Bradley Heights

PROJECT DESCRIPTION
SITE DEVELOPMENT IMPROVEMENTS, INCLUDING CLEARING, GRADING, RETAINING WALLS, PARKING LOT, STORM DRAINAGE, SANITARY SEWER MAIN, WATER MAIN FOR 236 UNIT MULTI-FAMILY DEVELOPMENT.

Grading Plan

Retaining Wall A Plan

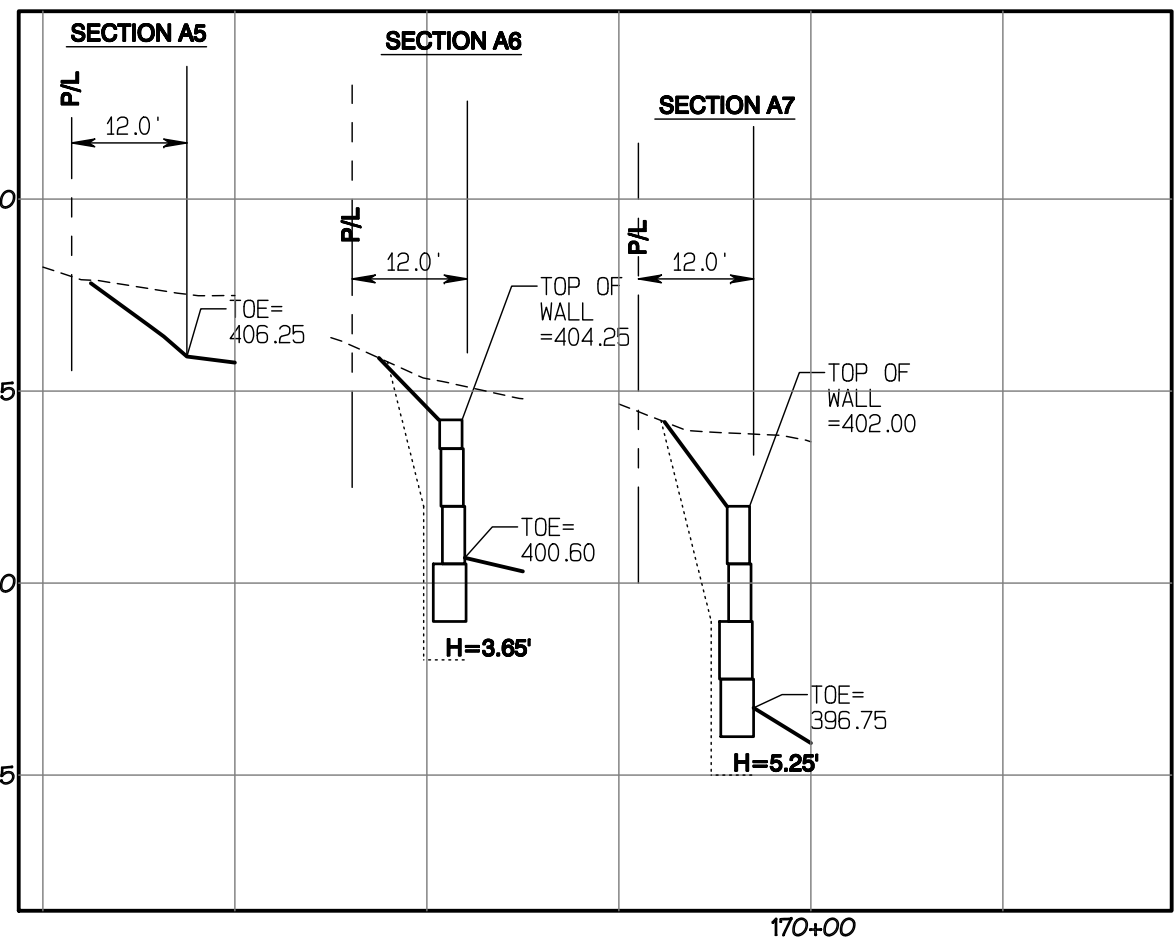
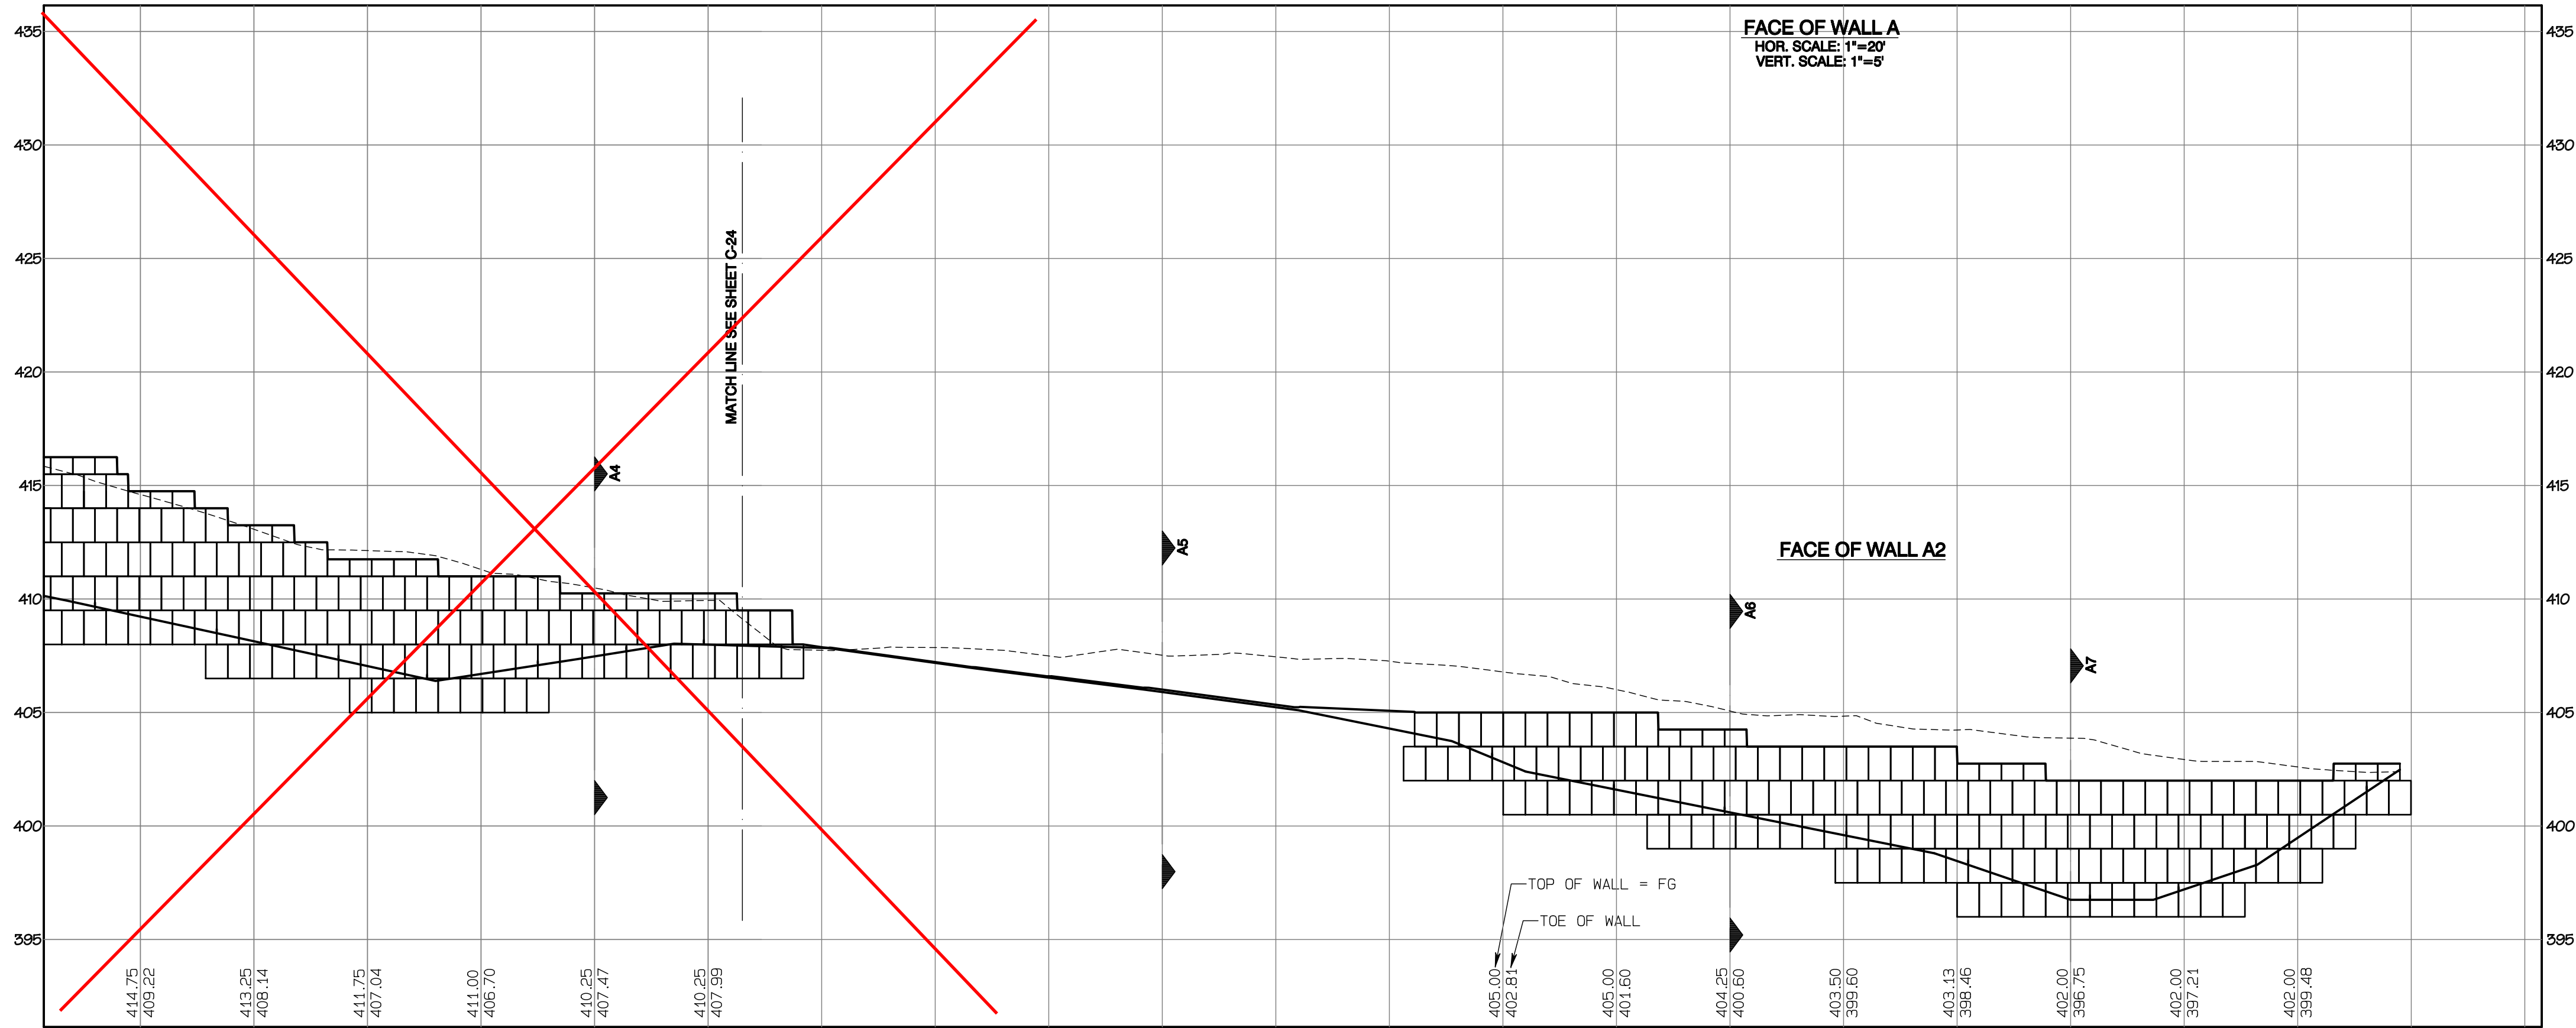
The proposed retaining wall weepholes drain system is not permitted, especially when the outlet pipe discharges to a hard surface like a paved parking lot. On the site plan, indicate how and where the retaining wall footing drain will connect to the site's storm system designed under civil construction permit application PRCCP20240845. Moreover, verify that the entire footing drain will have adequate slope to drain to a discharge pipe due to the significant elevation change along the wall. The additional stormwater pipes may need to be depicted on the PRCCP20240845 plans.
